DISPUTE OVER THE STATUS AND USE OF THE
WATERS OF THE SILALA

**REJOINDER OF THE
PLURINATIONAL STATE OF BOLIVIA**

Analysis and assessment of Chile's
reply to Bolivia's counter claims on the
Silala Case

Prepared for Pluri-national State of Bolivia, DIREMAR
Represented by Dr. Emerson Calderón

Figure 1 Geologic cross section near the Chilean border (Sergeomin, 2017)

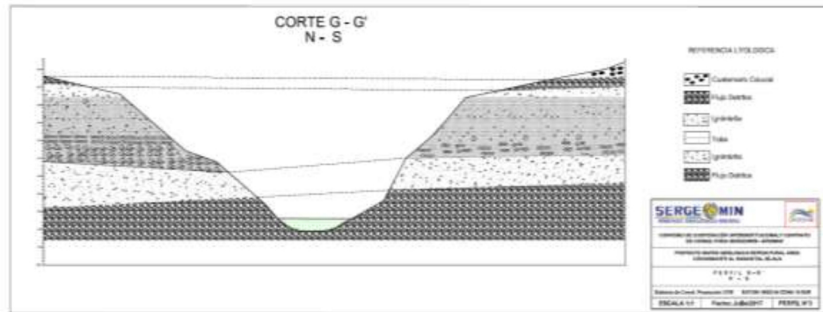
and Orientales wetlands and above the latter. Sergeomin (2017) geologic mapping indicates a relatively small displacement of 5 m at the border (Figure 1). This is not visible at the scale of the conceptual hydrogeologic cross section (Figure 36, Annex F), but a small displacement can be added to an updated figure to improve the conceptual aspects of the figure.

1. **Geologic maps** (Sergeomin, 2017) that includes a mapped fault along the main ravine near the border that splays to form the ravines that extend into the northern and southern wetland areas (Figure 1).

Figure 2 Geologic map of the Near Field area (Sergeomin, 2017)

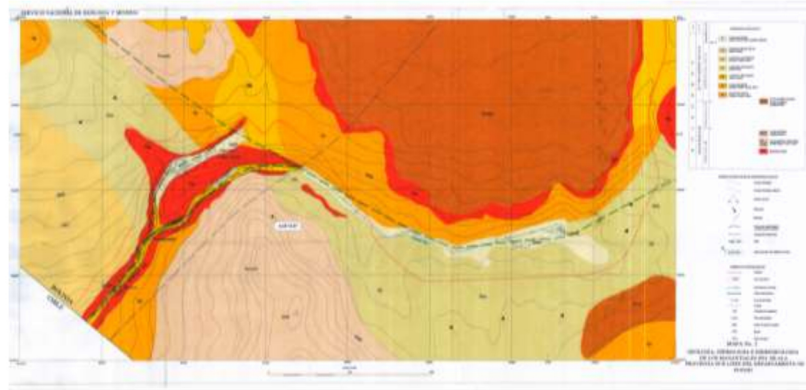
The mapped fault is consistent with the observed displacement between units on either side of the ravine as shown in Figure 2 and the findings of points 2 – 6. However, DHI

concedes that the precise geometry, transect and width of brecciated rock has not been perfectly determined. The width was approximated based on the geophysics and the ravine geometry, which is reasonable to capture groundwater flow patterns and fluxes through the Near Field.
